## AGENDA DESIGN ADVISORY PANEL MEETING

September 24, 2020, 5:00 PM Board Room, Service and Resource Centre, 411 Dunsmuir Street, Nanaimo, BC

## RE: RESPONSE TO DESIGN ADVISORY PANEL RECOMMENDATION, DP001187

#### DEVELOPMENT PERMIT APPLICATION NO. DP001200 – 155 FRY STREET

ELEVATIONS

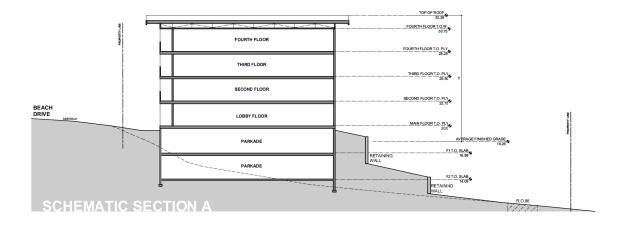
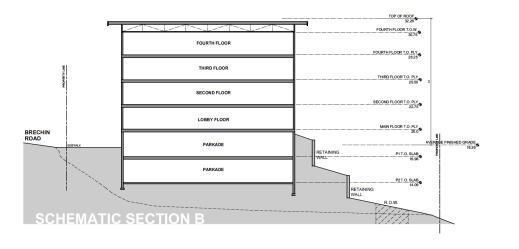
1. Consider opportunities to reduce the perceived vertical massing.

- Newcastle + Brechin Urban Design Guidelines: Section 2.12 Guideline #26 "Continuing neighbourhood patterns including green front yards is encouraged." (pg. 112)
- 8. Consider reducing the overall building scale, for example by removing the roof overhangs on the ends of the building and using more variety in the materials and colours.

- reduced the slope of the roof, bringing the height down;
- lightened the siding colour; and
- added more and larger window boxes in a natural wood colour to break up the verticality of the project.

To help reduce the perceived mass, lighter material has been added to the smaller ends of the building.

Lighter wood material has been added to the smaller ends of the building and additional (larger) window boxes to help lighten the overall project. The darker colour was also lightened throughout the building. We will not be stepping the building due to the higher potential of water ingress issues because of site exposure.

As noted above, we have added more of the lighter material throughout the building. The roof overhang on the parkade amenity space remains the same to meet the guideline of year-round

**AMENITY AREA**

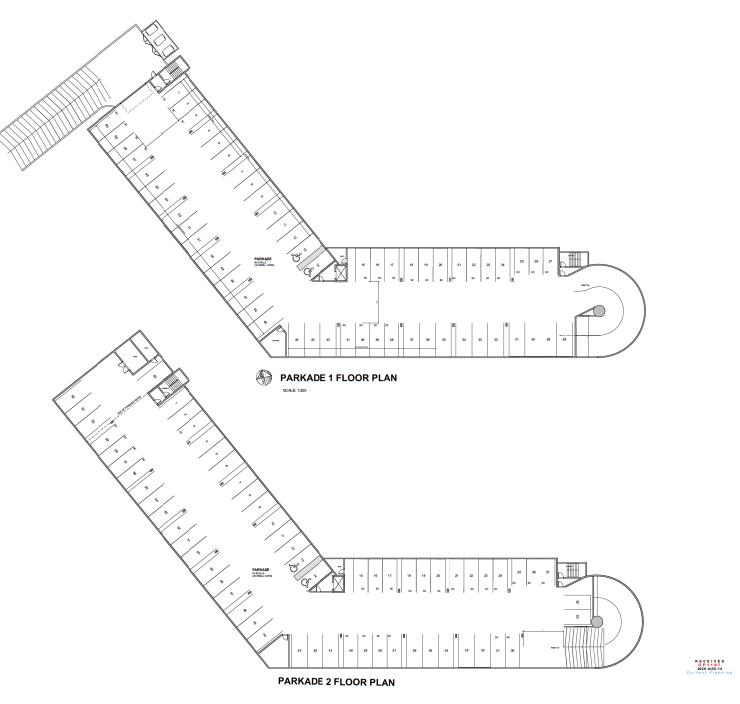
1. Consider ways to provide increased amenity space onsite.

We have added an amenity area to the parkade roof that is accessible from the main floor of the building.
